SYDNEY METRO PITT STREET NORTH OVER STATION DEVELOPMENT

Response to Submissions
(SSD 10375 & SSD 8875-Mod-1)

Prepared for
PITT STREET DEVELOPER NORTH PTY LTD
13 November 2020

Figure 1 Typical Level 10 Balustrade

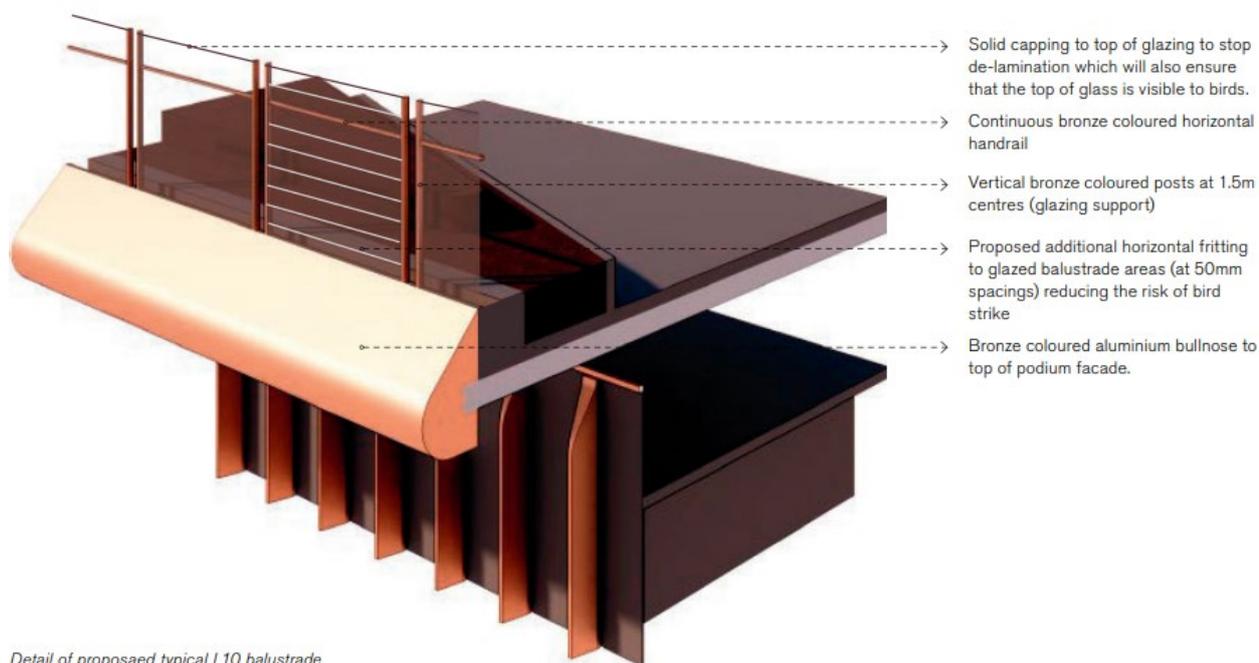
To further mitigate against the risk of birds striking the building a localised translucent treatment to the glazed balustrade surrounding the Level 10 and 11 roof terraces is proposed as illustrated in **Figure 1**. The glazing decal/ fritting will have 50mm horizontal spacings in line with Bird Safe USA guidelines.

Vertical bronze coloured posts at 1.5m intervals, a continuous bronze coloured horizontal handrail and solid capping to top of glazing will further ensure the glass is visible to birds.

Figure 2 Comparison of SSSA and RtS Roof Design

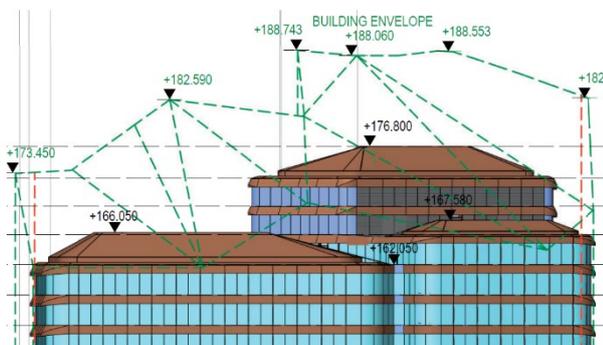
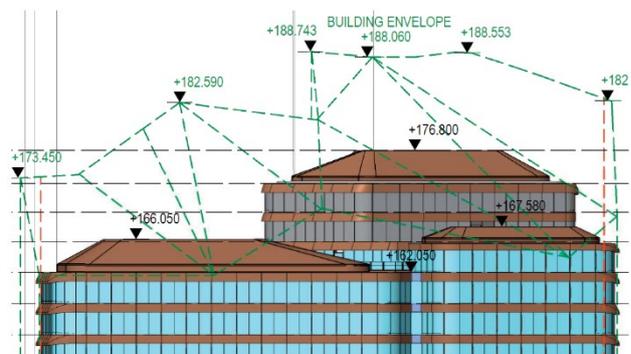
The lowest roof has an RL of 166.050, the intermediate roof has an RL of 167.580 and the highest roof of the built form has an RL of 176.800. All are located below the critical Solar Access Plane as illustrated on the diagram to the left in **Figure 2**.

The roof inclination has been altered to maximise the plantroom area while remaining within the approved Stage 1 Concept envelope and creating an elegant architectural solution to the fifth elevation. The three stepped roof volumes are still wholly contained within the approved building envelope, with the RLs of the original submission remaining unchanged. However the shape of the flat top surfaces of the roof have been amended to soften their appearance and bring them more in alignment with the design philosophy and organic nature of the rest of the building.

Figure 3 Updated design – Indicative 3D perspective illustrating integrated BMU track

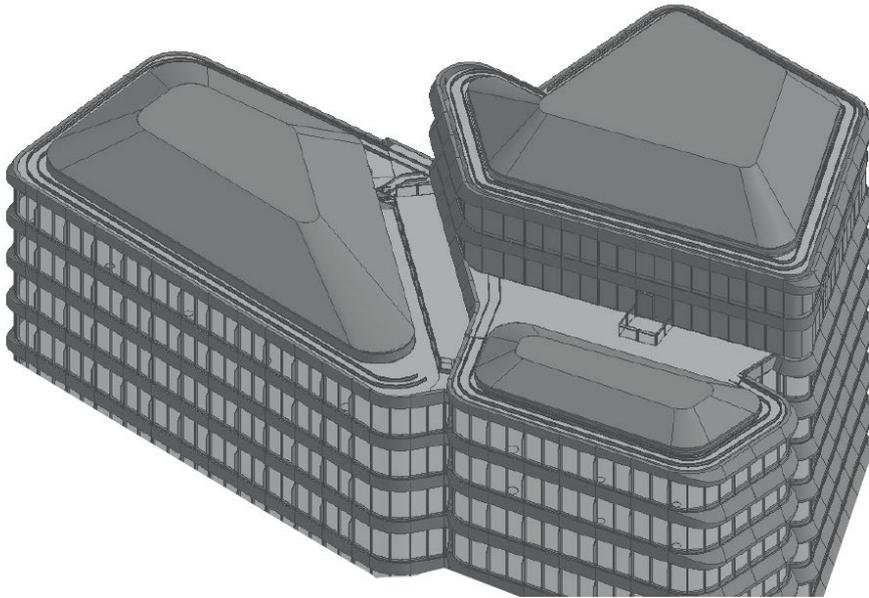
The BMU parking areas have been discretely integrated into the sides of the roof shape. Additional detail has been added in the form of the BMU tracks which sit within the recessed slot at the perimeter of each roof volume (see **Figure 3**). The BMUs can be hidden entirely within the main massing of the building (intermediate and highest roof volume) or hidden below the slope of the roof (lowest roof volume) when not in operation.

Figure 4 Indicative location for PV Cells

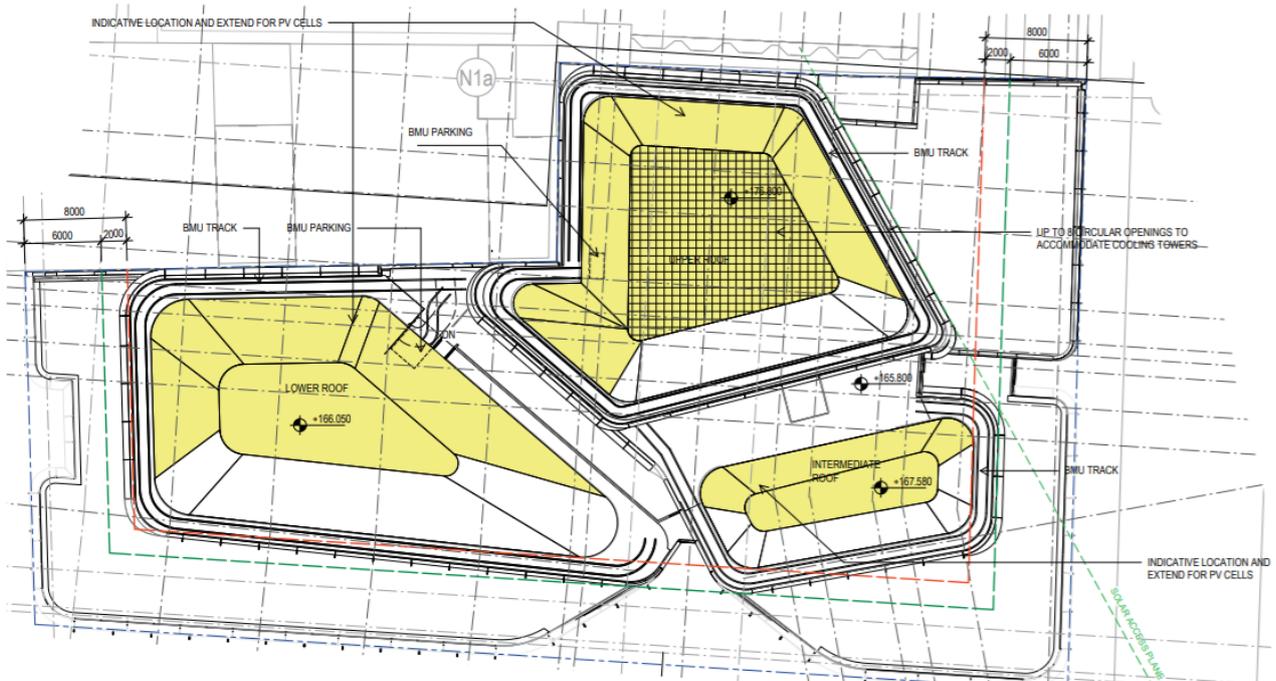
An indicative zone for the location of Photovoltaics (PV) is indicated in yellow in **Figure 4** below. The exact specification and placement of these cells will be integrated into the roof design and is subject to ongoing design coordination.

Up to eight circular openings will be located in the trafficable mesh of the upper roof to accommodate the required cooling towers. The number and location of these openings is subject to final plant selection but will be contained wholly within the roof form.

Figure 5 Castlereagh Street Podium Façade amendments

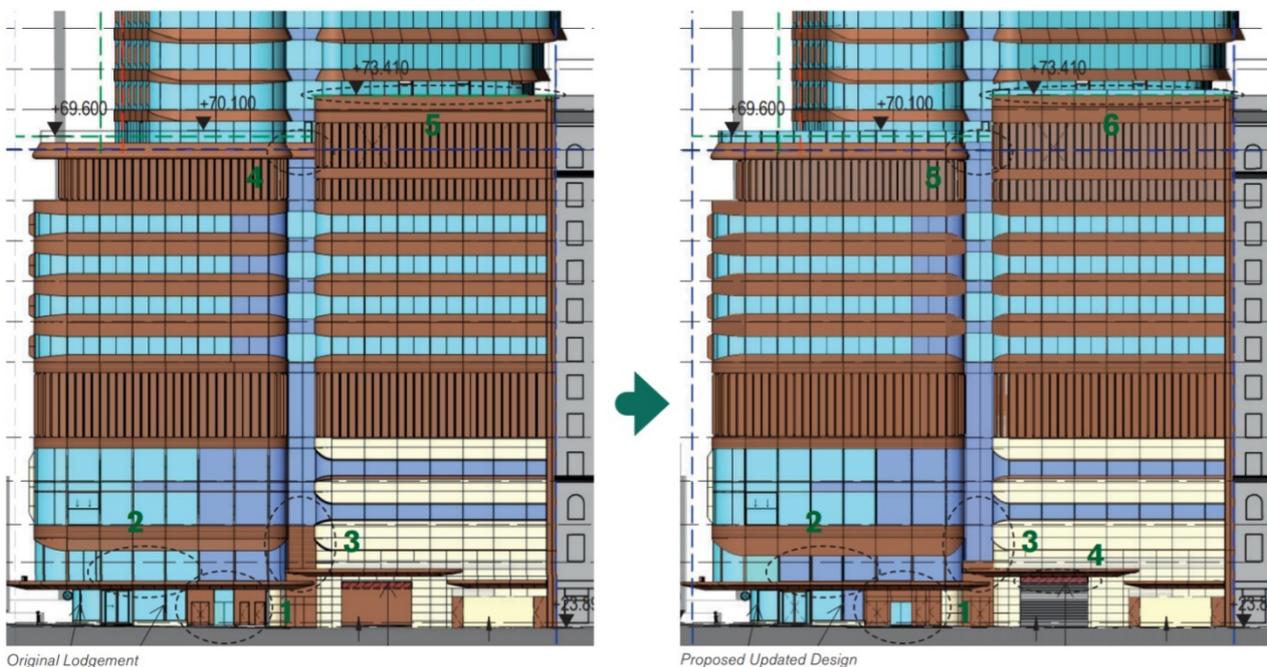
2. Station plantroom facade on Level 1 was incorrectly shown as glass curtain wall in the SSD DA plans and has now been revised to back painted glass. This element is subject to CSSI approval and is illustrated for coordination purposes only. *This was an error in the original lodgement.*

4. The height of the loading dock entrance has been slightly increased to cater for the increased height requirements given the station plant equipment replacement strategy required by Sydney Metro. This element is subject to CSSI approval and is illustrated for coordination purposes only.

5. The top of the slot between the two podium elements has been revised to be a glass spandrel panel to better accentuate the two podium volumes either side of the podium slot.

6. A glazed upstand / balustrade has been added to the top of the solid upstand on the north east corner of the development on Level 11. *This was an error in the original lodgement drawings, although it was noted in the Architectural Design report.*

Figure 6 Pitt Street Podium Façade amendments

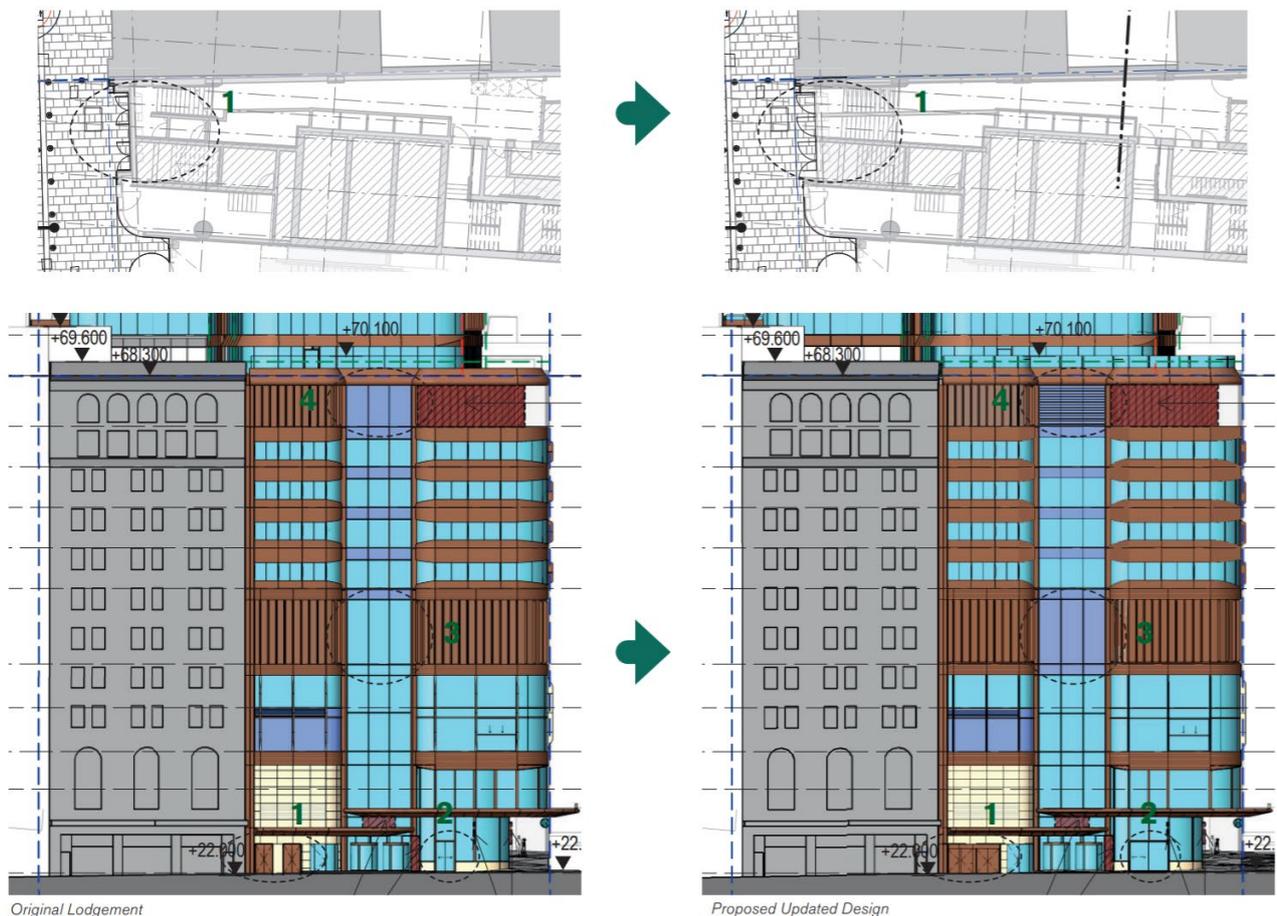
1. The gas meter room on the ground floor now has a direct access point to Castlereagh Street. The fixed strip between the egress doors is now bronze clad rather than stone. This element is subject to CSSI approval and is illustrated for coordination purposes only.
2. Increased DDA entrance sliding door width. This element is subject to CSSI approval and is illustrated for coordination purposes only.
3. Plantroom facade on Level 4 was incorrectly shown as glass curtain wall in the SSDA plans and has now been revised to back painted glass. This element is subject to CSSI approval and is illustrated for coordination purposes only. *This was an error in the original lodgement.*
4. The plantroom facade on Level 9 now has glass louvers instead of a solid spandrel facade.

Figure 12 Alternate Massing Option 1

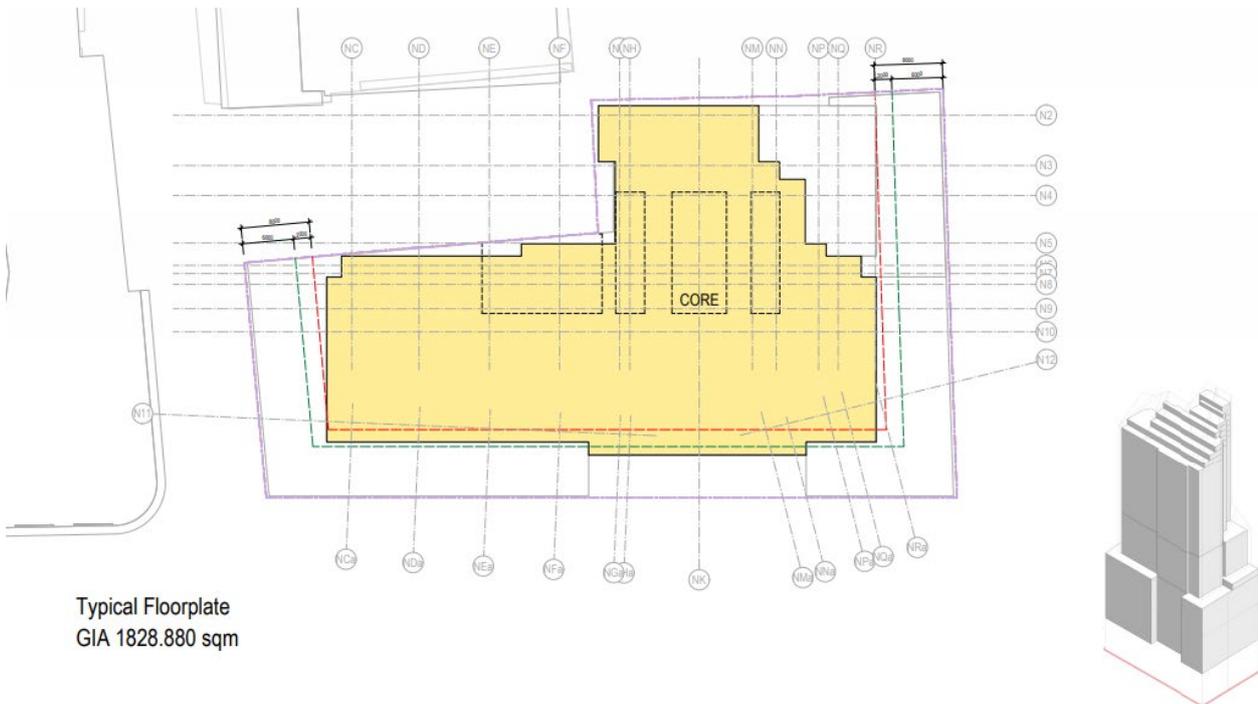
Option 1 illustrated in **Figure 12** consists of an equivalent GFA to the proposed design but an unrefined building massing which does not respond to the Design Guidelines or design parameters established by the DRP. This option was an early bid-phase scheme for the PSN OSD project. When compared to the proposed SSD DA scheme, this option results in a decrease in the number of St Regis apartments receiving greater than 2 hours of direct sunlight to their living spaces as illustrated in

Figure 13 Alternate Massing Option 2

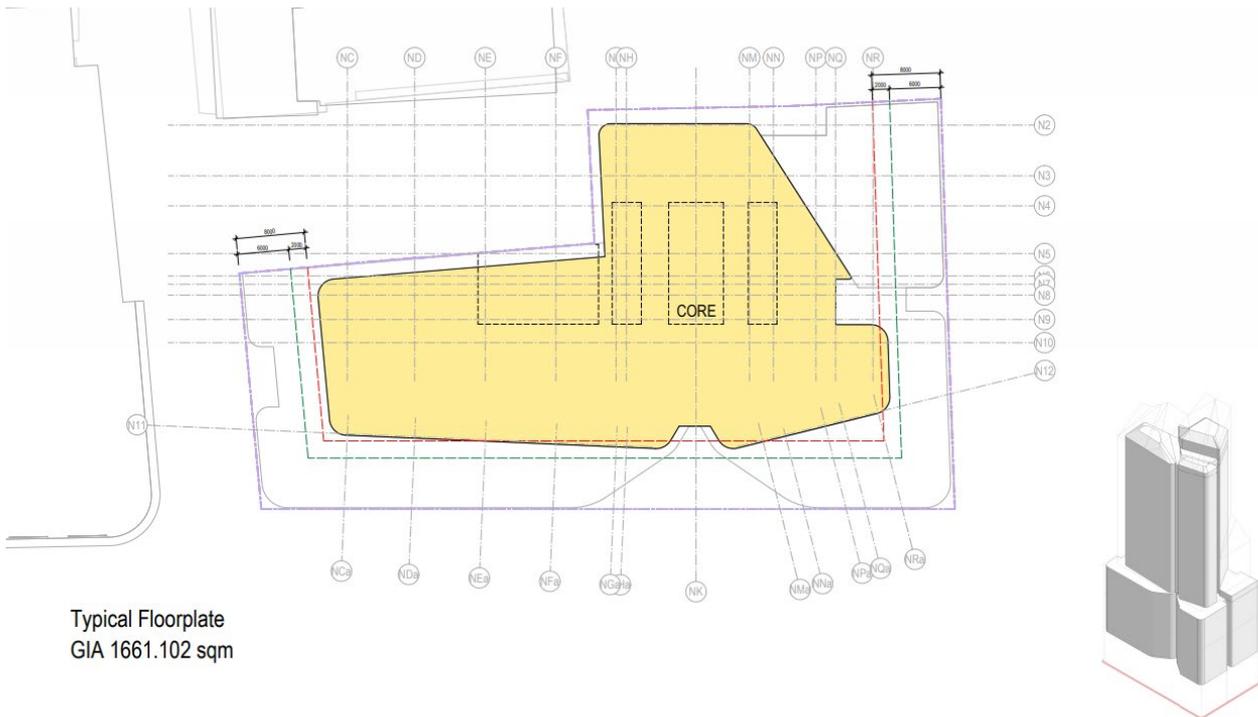
Option 2 illustrated in **Figure 13** consists of approximately a 5,000m² reduction in GFA equivalent to the additional GFA sought within the MOD and Detailed SSD DA. The reduction in GFA has been achieved through reducing the building massing by 1m on all sides. This option remains consistent with the design direction of the proposed SSD DA scheme and similarly responds to the Design Guidelines and design parameters established by the DRP. In this regard, it is considered to be a scheme that most closely reflects the significant design review rigour of the proposed SSD DA scheme, addressing all the various design and commerciality parameters, yet maintains a GFA consistent with the Concept Consent. Analysis find that this form does not result in an increase in solar access to the Park Regis residential apartments as illustrated in **Table 9**.

Figure 14 Alternate Massing Option 3

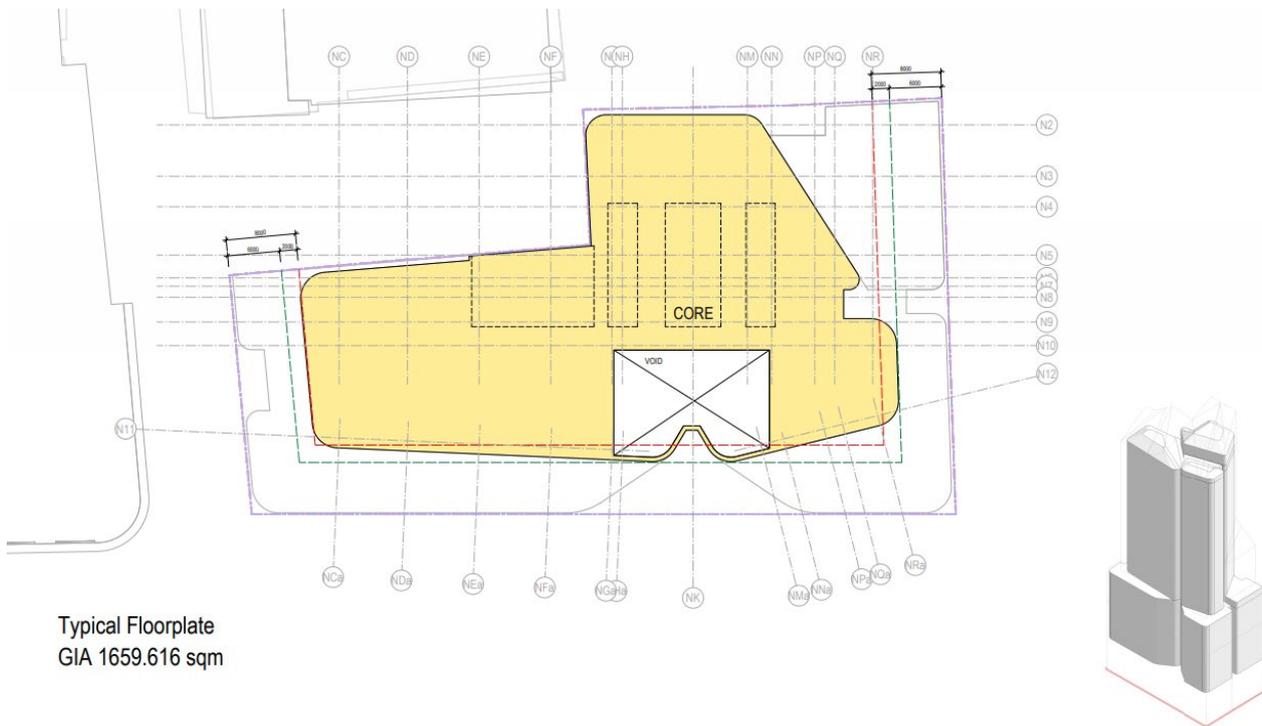
Option 3 illustrated in **Figure 14** consists of an approximately 5,000m² reduction in GFA achieved through the introduction of a void within the proposed building massing. This option responds to all the Design Guidelines and design parameters established by the DRP with the exception of the provision of 'large contiguous floor plates'. The floor plates within this option are disjointed and less fit for purpose than that of the SSD DA scheme. This option results in no change in solar access as illustrated in **Table 10**.

Figure 15 Draft Plan of Subdivision showing Proposed Right of Public Access

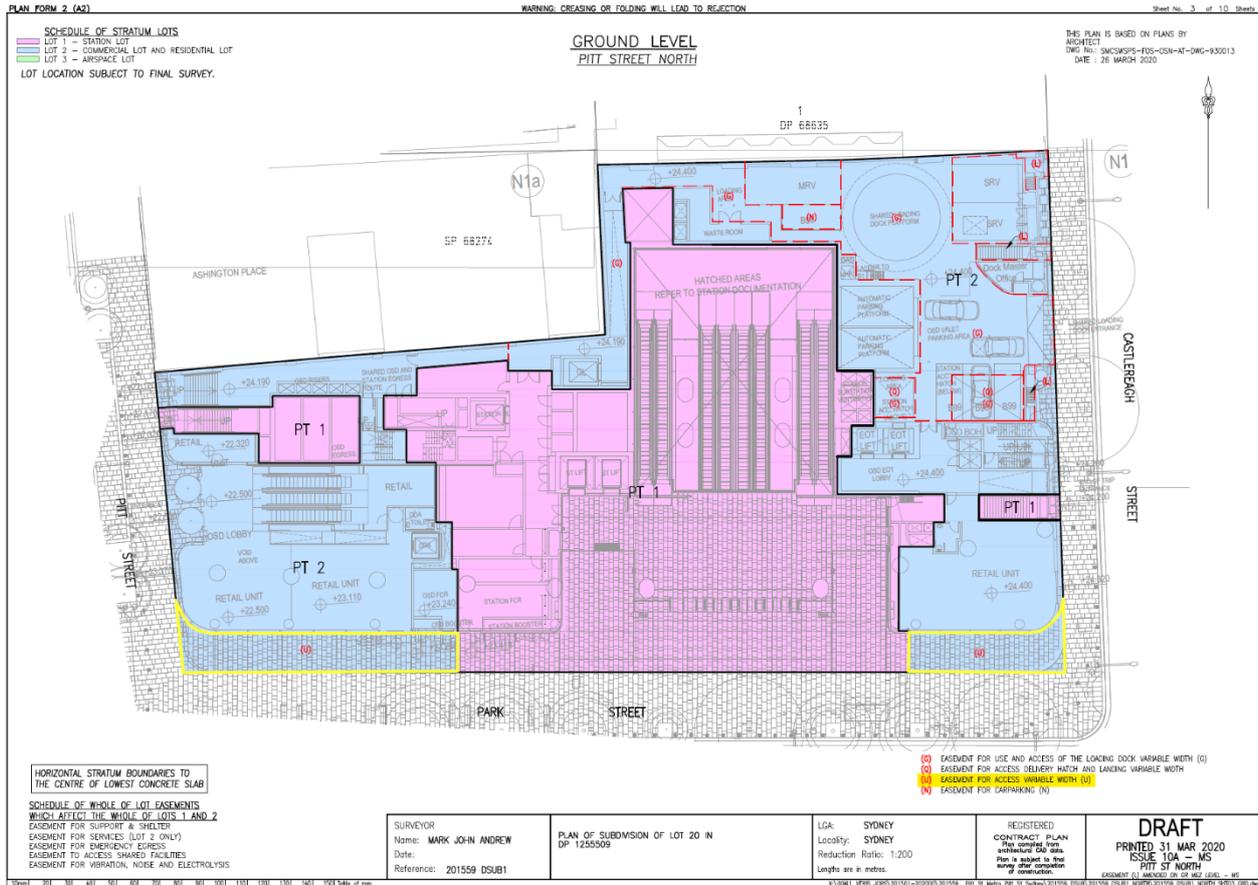
It is proposed to dedicate to the City of Sydney Council an easement for Right of Public Access for land below the podium undercroft along the Park Street frontage of the site, shown in the Draft Plan of Subdivision at **Appendix H** and extracted below at **Figure 15**.

Dedication of the Right of Public Access will enable Oxford Property Group (owner of Pitt Street Developer North) to retain freehold ownership of the pathway land while granting Council a registered and enforceable interest which would bind successors in title. This Right of Public Access will ensure in perpetuity this land is usable as an extension to the public footpath around the site.
